INTERNAL CORRESPONDENCE

SUBJECT: ECO Matrix and rework for IPB, IOC, DRR Boards REV 3

This document contains the rework required to up-grade the IOC, IPB, DRR Channel and interface boards to the latest correct dash and REV level.

FIGURE 2

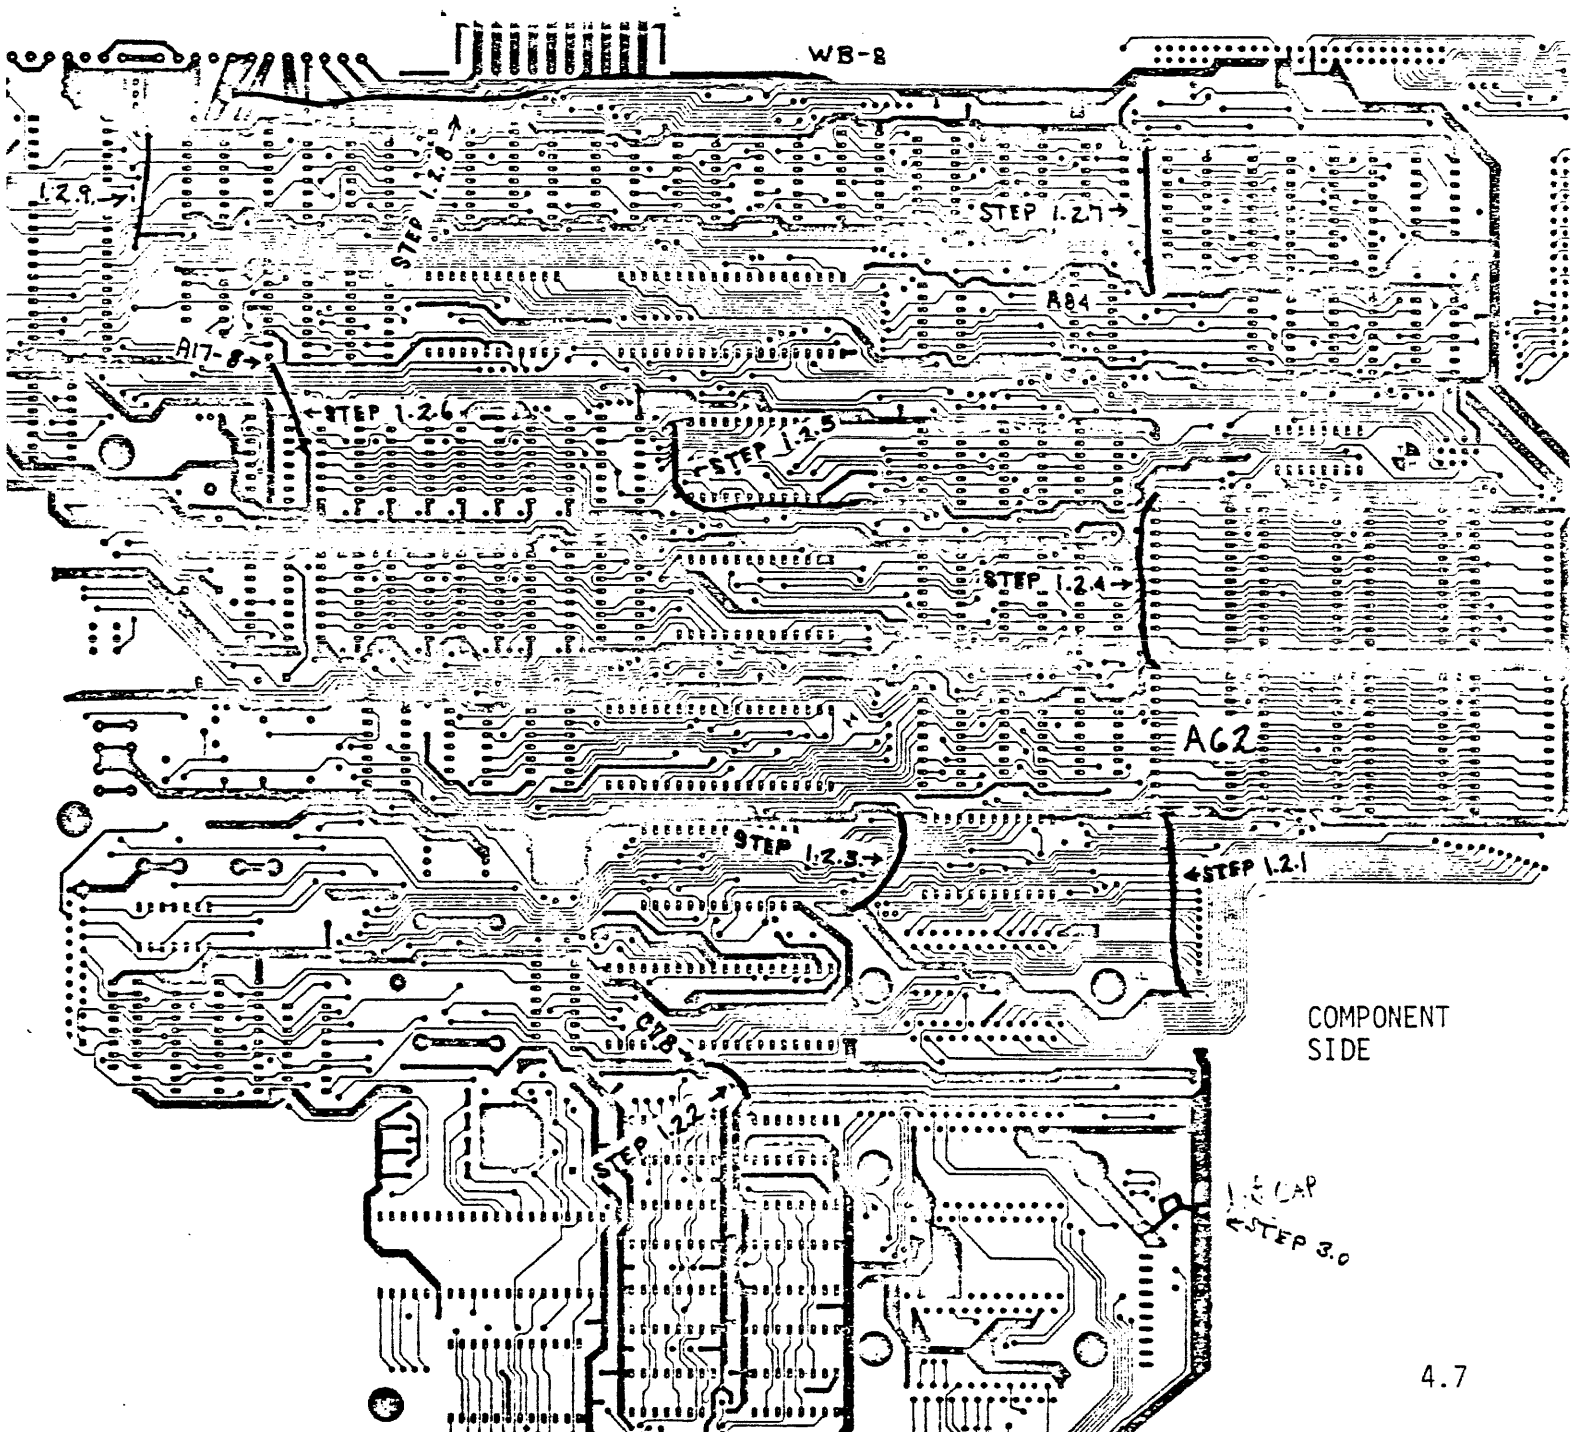
1.2.3 From double feedthru on gnd bus beside A66-28 to A67-12

FIGURE 3

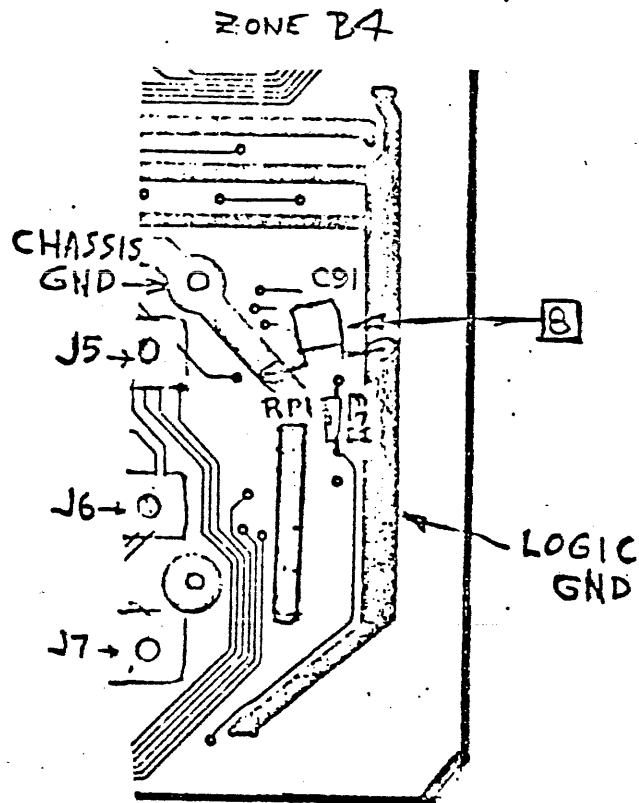
- 1.2.4 From bus at lead of R37 to double feedthru near A50-1.
 - 1.2.5 From bus running under body of R26 at C24 lead to bus connecting C23 and A35-12.
 - 1.2.6 From bus at lead of C19 (going to C28) to A17-8.
 - 1.2.7 From gnd bus between A84-16 and C16 to heavy gnd bus at C8.
 - 1.2.8 From gnd bus at W8-B to double feedthru beside R6 single pad (bus running to J16 - 5 & 6).
 - 1.2.9 From bus between R10 & R11 to gnd plane at R6.
- 3.0 Solder $1\mu\text{F}$ capacitor 101754-061 from chassis gnd to logic gnd by R53.
(SEE FIGURE 3)

ECO 1805

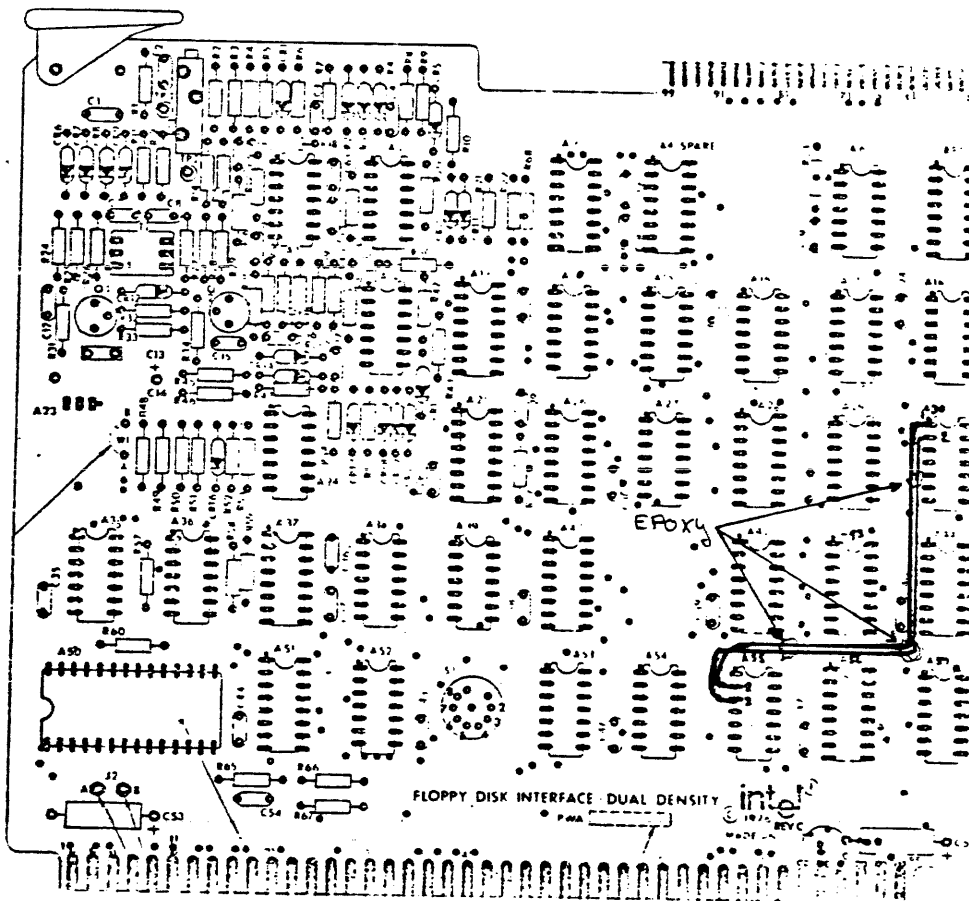
1. Remove Pin 3 A55 from the board and cut the pin off as close to the body of the IC as possible.
2. Add a wire from A30 Pin 1 to A55 Pin 2 using 22 gauge wire.
3. Add a wire from A30 Pin 2 to the pad where A55 Pin 3 was formerly located.
4. Epoxy at point shown in figure below:

ECO 3841

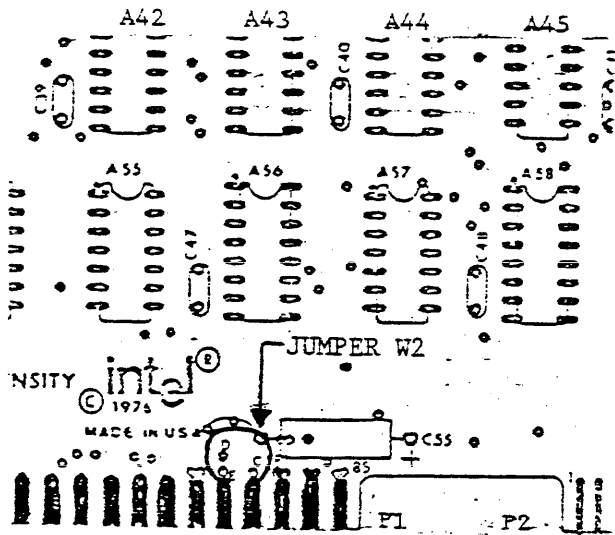
1. Location of jumper W2 must be changed from D to C and changed to D to E, to utilize -10V power supply in Series II.

Fig. 3

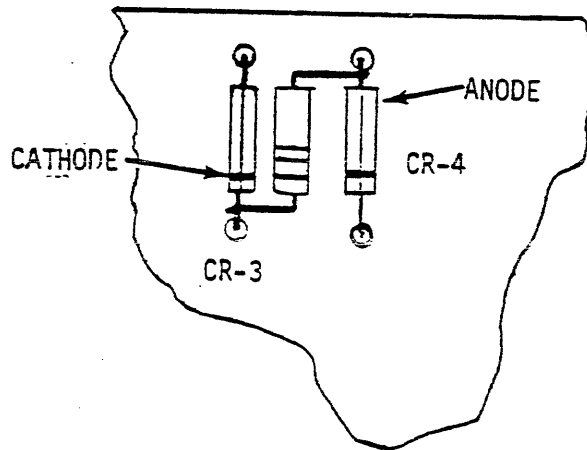
2.) Add the following using Fig. 3:

Add the 15 ohm $\frac{1}{2}$ watt resistor from the cathode of CR-3 to the anode of CR-4 on the component side of the board.

ECO 1630 - PWA 101241-04 REV. 12 TO REV. 13, USING PWB 1001242-04 REV 8.

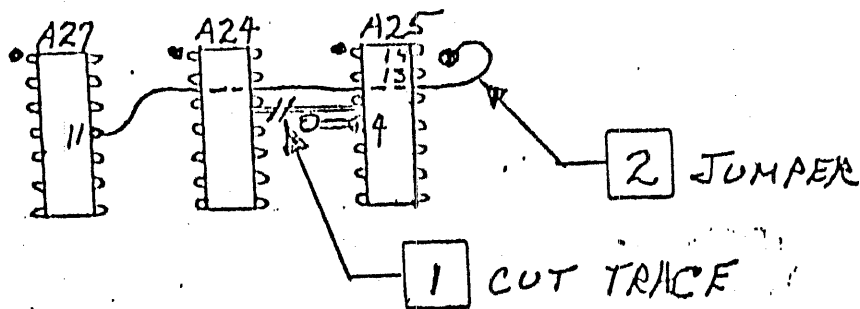
- STEP **1** CUT TRACE ABOVE FEEDTHRU BESIDE A25-4 (COMPONENT SIDE).
- STEP **2**, ADD JUMPER FROM A27-11 TO FEEDTHRU BESIDE A25-13 (COMP. SIDE),
RUNNING WIRE UNDER A24 & A25.

- STEP **3** MARK ECO 1630 ON SOLDER SIDE OF BOARD.

2 CUT TRACE BETWEEN

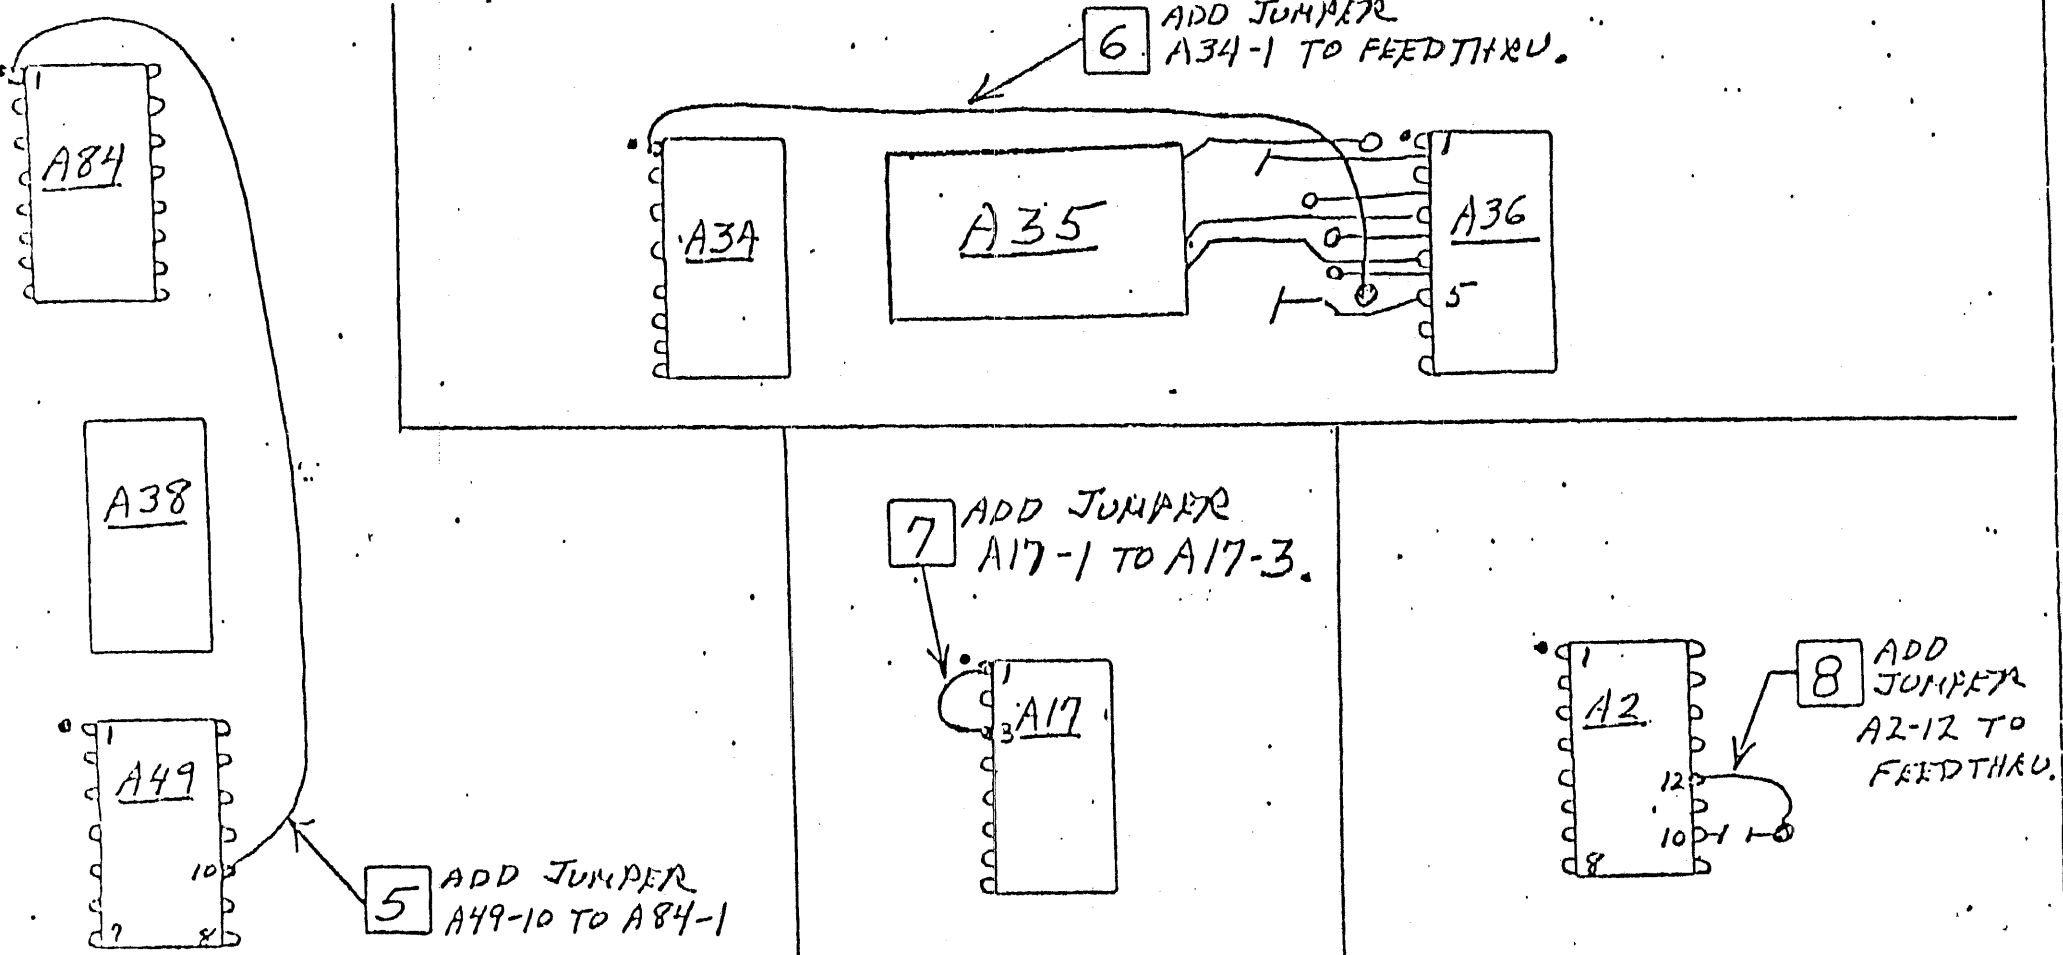
3 CUT TRACE A2-10 TO

4 CUT TRACE COMING OUT BETWEEN A34-11 & 12.

- STEP 5 ADD JUMPER FROM A49-10 TO A84-1. (COMPONENT SIDE).
- STEP 6 ADD JUMPER FROM A34-1 TO FEED THRU ADJACENT TO A36-5 (COMP. SIDE).
- STEP 7 ADD JUMPER FROM A17-1 TO A17-3 (COMPONENT SIDE).
- STEP 8 ADD JUMPER FROM FEEDTHRU ADJACENT TO A2-10 TO A2-12 (COMP. SIDE).
- STEP 9 ADD JUMPER FROM A6-11 TO J18-16 (SOLDER SIDE).
- STEP 10 ADD JUMPER FROM A6-12 & 13 TO A1-39 (SOLDER SIDE).

2699A (CONT'D) PWB 1001242-04 REV. 8 & 11 ONLY.

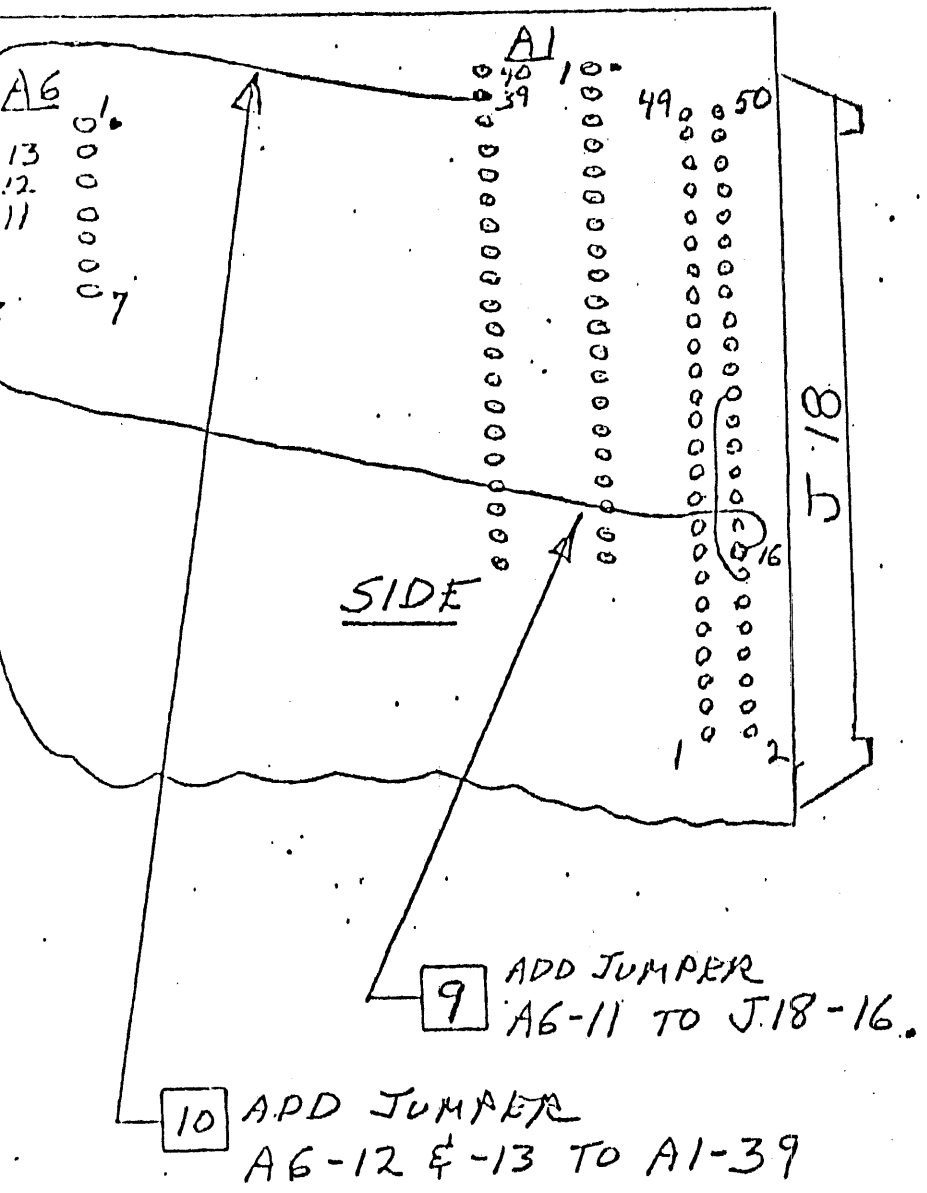
STEP 11 ADD (1EA) 470-Ω RESISTOR
P/N 56-019 FROM A68-6 TO
A68-16 (COMPONENT SIDE).

11 ADD 470 OHM RESISTOR
(56-019) A68-6 TO A68-16

ECO 2699 A (CONT'D) NOTE: FOR 1001242-04 REV. 8, 11, 12 & 13.

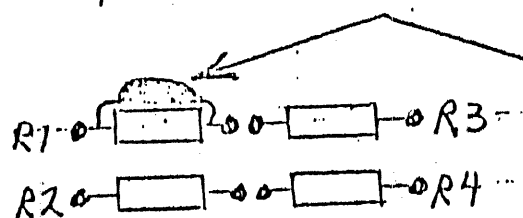
STEP 12 ADD CAPACITOR C-90 IN PARALLEL TO RESISTOR R1.
P/N. 64-007 CAP. CER, .01UF $\pm 20\%$ 25V.

12 ADD CAPACITOR IN.
PARALLEL TO R1

ITEM 2 WAS 2002413 SCHEMATIC IS 2002583 SCHEMATIC

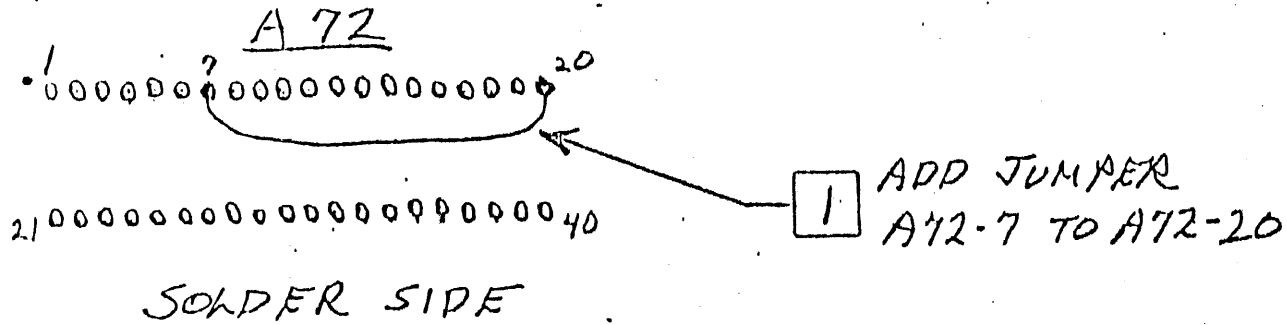
STEP 1 ADD JUMPER A72-7 TO A72-20 (SOLDER SIDE).

ECO 1630 - PWA 1001241-04 REV. 12 TO REV. 13, USING PWB 1001242-04 REV 8.

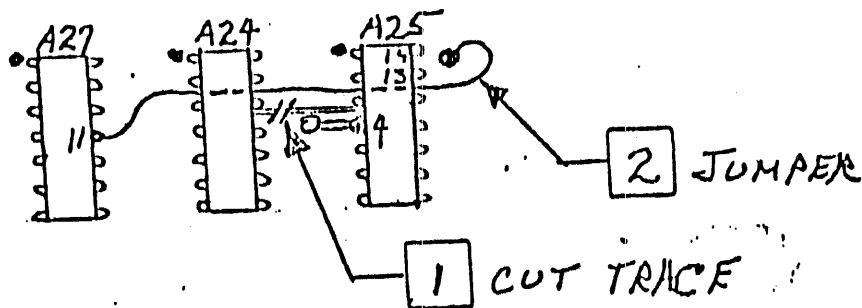
- STEP **1** CUT TRACE ABOVE FEEDTHRU BESIDE A25-4 (COMPONENT SIDE).
 STEP **2**, ADD JUMPER FROM A27-11 TO FEEDTHRU BESIDE A25-13 (COMP. SIDE),
 RUNNING WIRE UNDER A24 & A25.

- STEP **3** MARK ECO 1630 ON SOLDER SIDE OF BOARD.

699A (CONT'D) PW13 1001242-04 REV. 8 & 11 ONLY

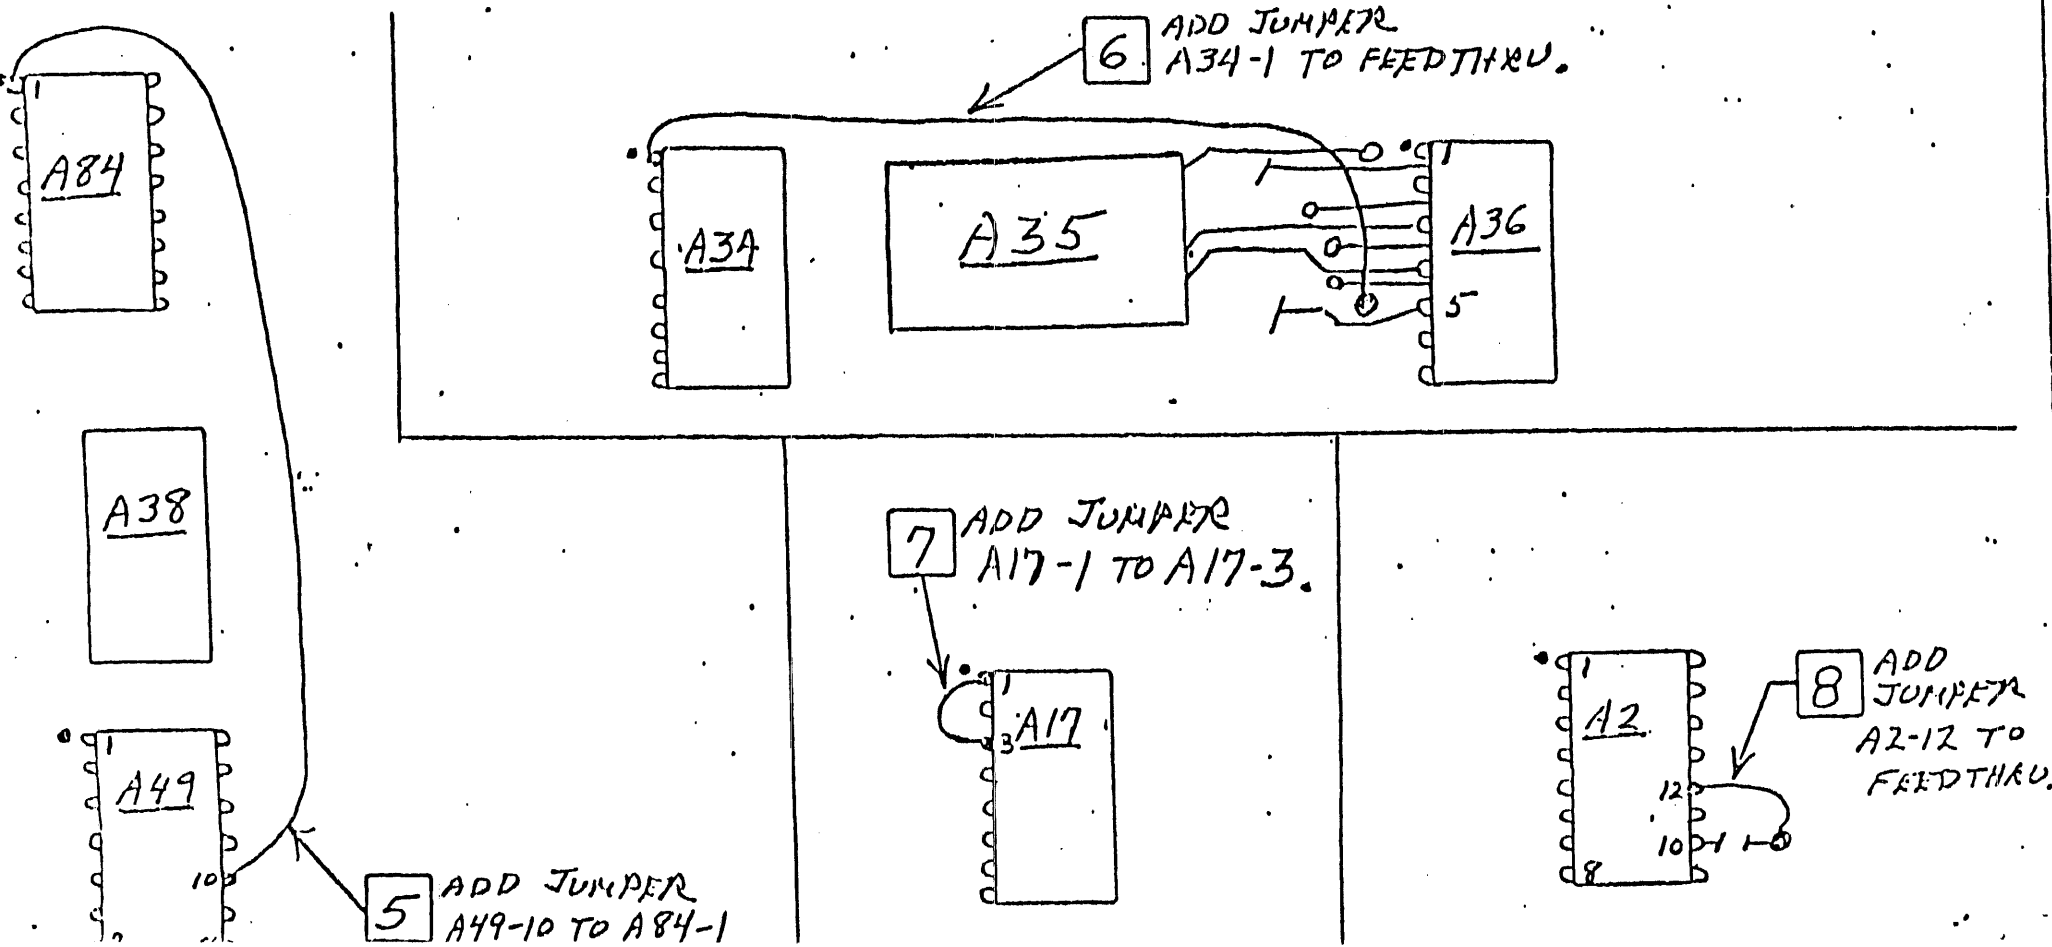
- STEP 5 ADD JUMPER FROM A49-10 TO A84-1. (COMPONENT SIDE).
- STEP 6 ADD JUMPER FROM A34-1 TO FEED THRU ADJACENT TO A36-5 (COMP. SIDE).
- STEP 7 ADD JUMPER FROM A17-1 TO A17-3 (COMPONENT SIDE).
- STEP 8 ADD JUMPER FROM FEEDTHRU ADJACENT TO A2-10 TO A2-12 (COMP. SIDE).
- STEP 9 ADD JUMPER FROM A6-11 TO J18-16 (SOLDER SIDE).
- STEP 10 ADD JUMPER FROM A6-12 & 13 TO A1-39 (SOLDER SIDE).
